Rezoning Transportation Analysis

Petition Number: 2023-013

General Location Identifier: 21917287

Date	Description
05-24-2023	First Review (PDM)

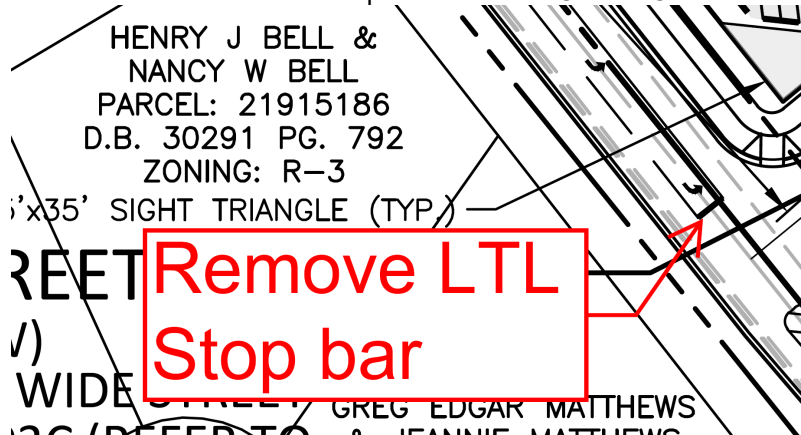
The Comprehensive Transportation Review was recently approved by City Council under the new UDO. CDOT is **requesting** the petitioner complete a CTR for the site. The petition's zoning falls within the medium to high intensity development which based on the 2,230 daily trips will trigger Tier 3 (9 mitigation points) for multimodal assessment, as found in the Charlotte Streets Manual.

As part of this request, the petitioner shall review and assess the publicly accessible pedestrian network within ¼ mile walking distance of the site to identify multimodal infrastructure to meet the Tier 3 (9 mitigation points) for multimodal assessment.
